# RENESAS TECHNICAL UPDATE

Product Category	MPU&MCU		Document No.	TN-H8*-A292A/E	Rev.	1.0
Title	Notes on Arbitration Lost in I <sup>2</sup> C Bus Interface of the H8S/2633 Series, H8S/2643 Series and H8S/2638,2639,2630 Group		Information Category	Technical Notification		
Applicable Product	H8S/2633W Series	Lot No.	Reference Document	H8S/2633 Series Hardware Manual (ADE-602-165C Rev.4.0) H8S/2639, H8S/2638, H8S/2636, H8S/2630 Group Hardware Manual (REJ09B0103-0500O Rev.5.00) H8S/2643 Series Hardware Manual (ADE-602-214A Rev.2.0)		
	H8S/2638W, 2639W, 2630W Group	All				
H8S/2643W Series

Figure 1 Diagram of Erroneous Operation when Arbitration is Lost

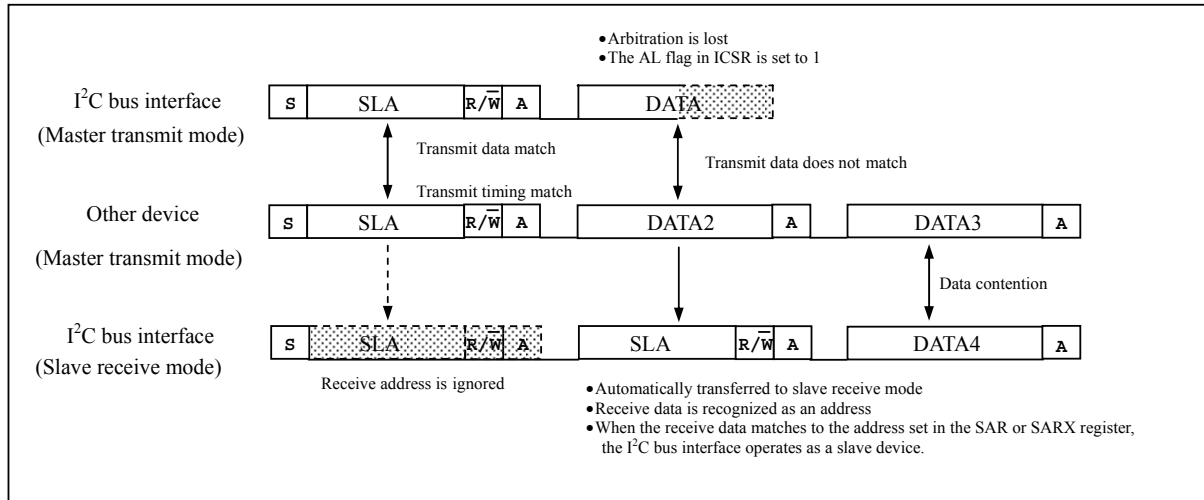
The I<sup>2</sup>C bus interface recognizes the data in transmit/receive frame as an address when arbitration is lost in master mode and a transition to slave receive mode is automatically carried out.

When arbitration is lost not in the first frame but in the second frame or subsequent frame, transmit/receive data that is not an address is compared with the value set in the SAR or SARX register as an address. If the receive data matches with the address in the SAR or SARX register, the I<sup>2</sup>C bus interface erroneously recognizes that the address call has occurred. (See figure 1.)

In multi-master mode, a bus conflict could happen. When the I<sup>2</sup>C bus interface is operated in master mode, check the state of the AL bit in the ICSR register every time after one frame of data has been transmitted or received.

When arbitration is lost during transmitting the second frame or subsequent frame, take avoidance measures.
